PATENT
Serial No. 10/524,570

Amendment in Reply to Non-Final Office Action of July 10, 2006
Confirmation No. 8445

Amendments to the Drawings:

Appl. No. 10/524,570
Reply to Office Action of July 10, 2006
Annotated Sheet Showing Changes

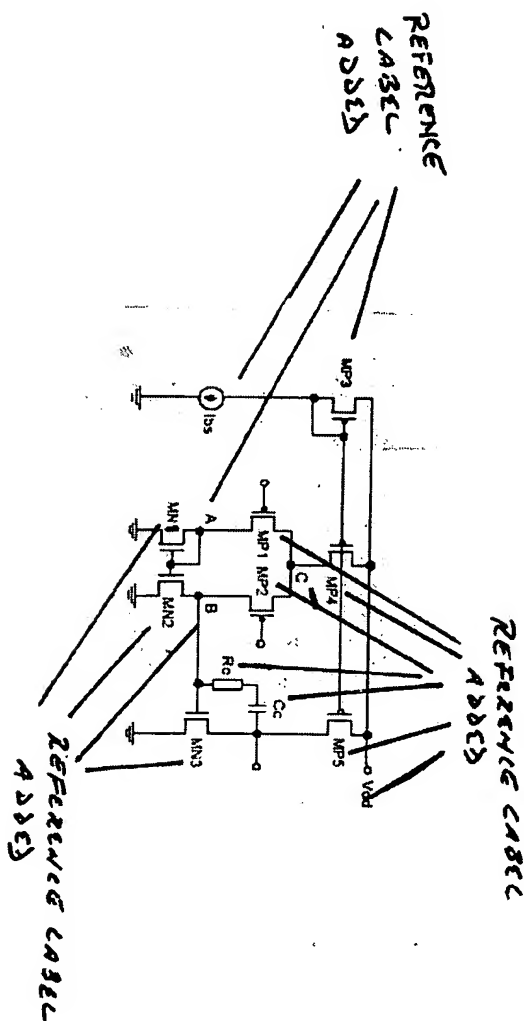
The attached drawing sheets include changes to FIGS. 1, 2 and 4, respectively. These sheets replace the original drawing sheets including FIGS. 1, 2 and 4. In each of FIGS. 1, 2 and 4, reference signs have been added as mentioned in the detailed description.

In the Office Action, the drawings were objected to for failing to include reference labels as specified in the detailed description. Proposed new drawings, Figures 1, 2 and 4, are provided in response to the objection. Applicants respectfully request withdrawal of the drawings objection and approval of the enclosed proposed drawing changes.
